MEMORANDUM

TO: District of Columbia Zoning Commission

DATE: July 10, 2020

SUBJECT: ZC #12-01C – Catholic University – Campus Plan Amendments and Further Processing for a New Dorm

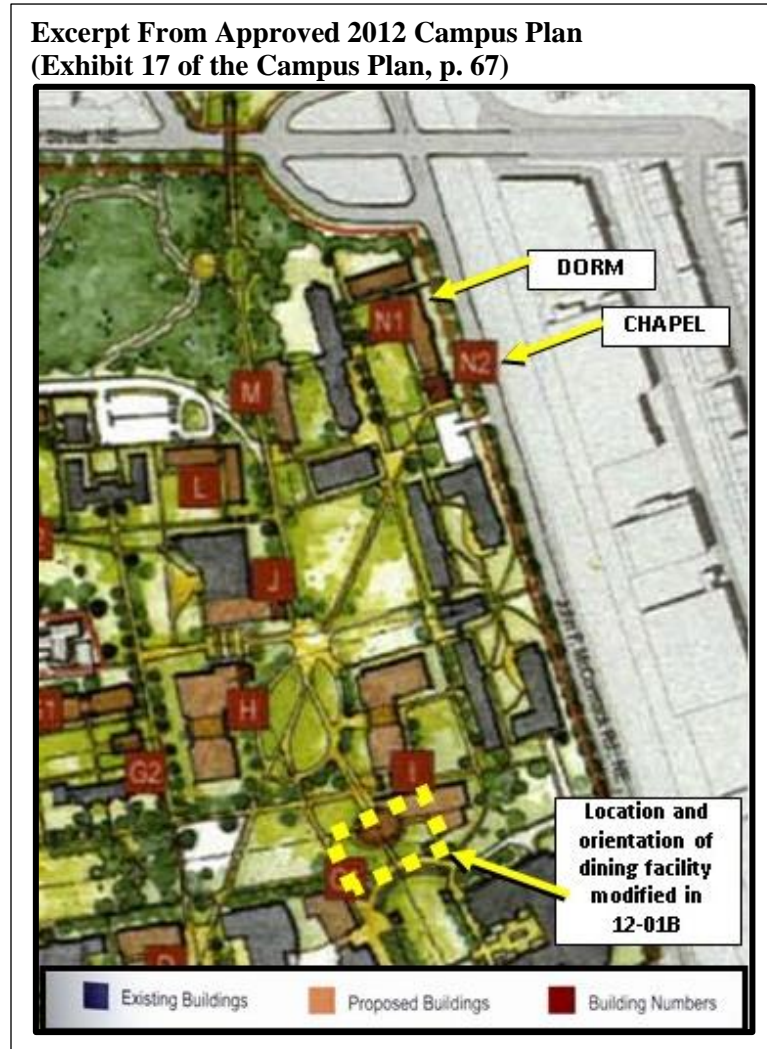
The application requires two amendments to the campus plan. The first amendment would adjust the location of a chapel from where the campus plan had proposed it. Please see the excerpt from the approved campus plan below, where the dorm in question is labeled “N1” and the chapel “N2”. See also Attachment 2, a conceptual rendering of the chapel and dorm from the campus plan.

The present application proposes that the chapel be located roughly at the center of the quad formed by the new dorm and Opus Hall, although still attached to the new building. The dorm itself would then extend further to the south to occupy the space left from the move of the chapel.

Attachment 2
Rendering of Chapel and Associated Dorm from Approved Campus Plan (p. 70)

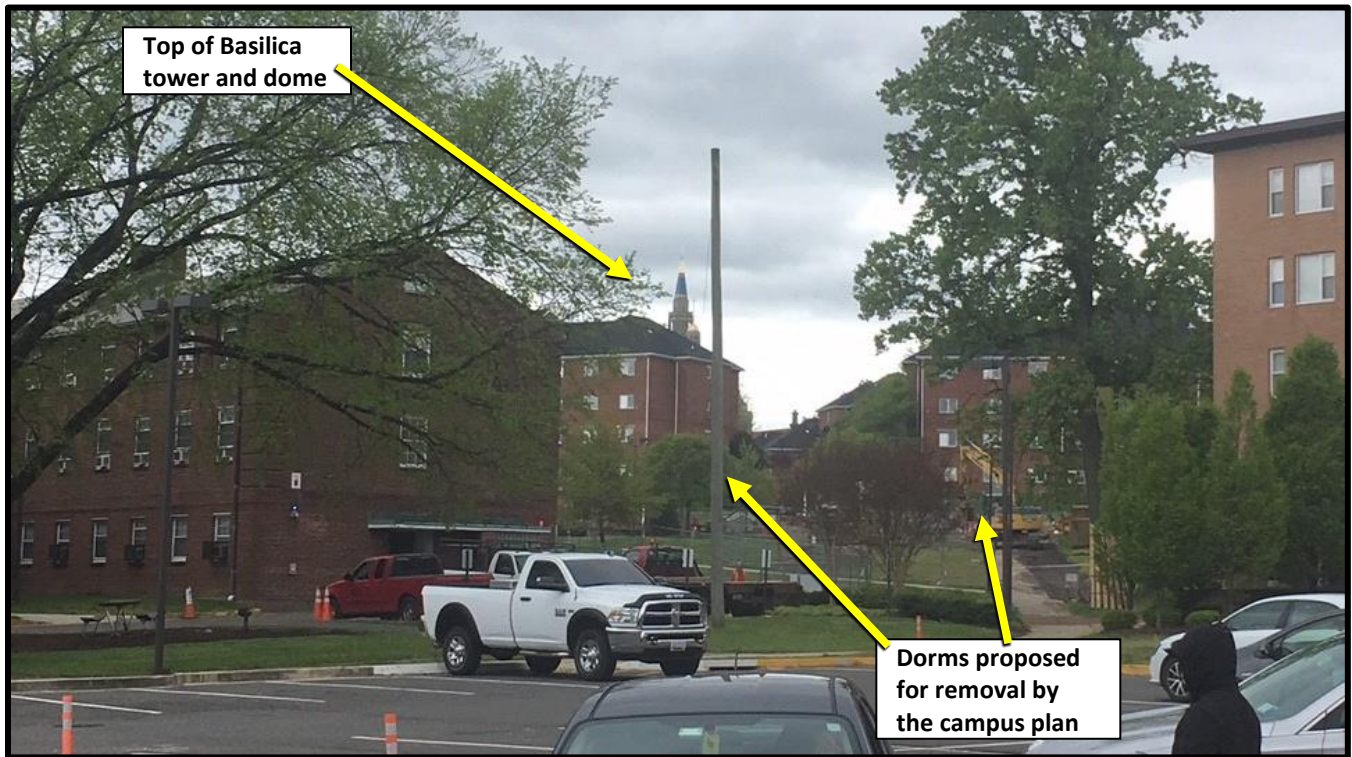
This amendment would move the chapel off of a primary view axis shown in the approved Campus Plan, which would have visually and thematically linked the chapel with the Basilica of the National Shrine of the Immaculate Conception. See Attachment 4 for a diagram of the view axes proposed in the plan. As buildings on campus are demolished, in conformance with the plan, the view of the Shrine from the chapel’s approved location, now limited to the very top of the Shrine’s dome and tower, will be more complete. See existing conditions photo in Attachment 3.

Under the proposed change, the chapel would no longer serve as a visual terminus for this viewshed. Rather, the viewshed at this end would generally terminate at the south end of the new quadrangle and the south-west corner of the dorm. The relocated chapel would serve as the visual focal point for the immediate quadrangle, both upon entering the space and for those using the courtyard. The applicant stated to OP that the move would allow for the creation of two defined courtyard areas – one more passive and one more active – rather than one and would allow for a more successful integration of the chapel into the daily life of the students. Because the dorm would be divided into male and female wings, having the chapel and other student activity areas in the center would allow for easier access from both portions of the building. In addition, the entrance to the chapel wing is intended to be easily accessible from Opus Hall.
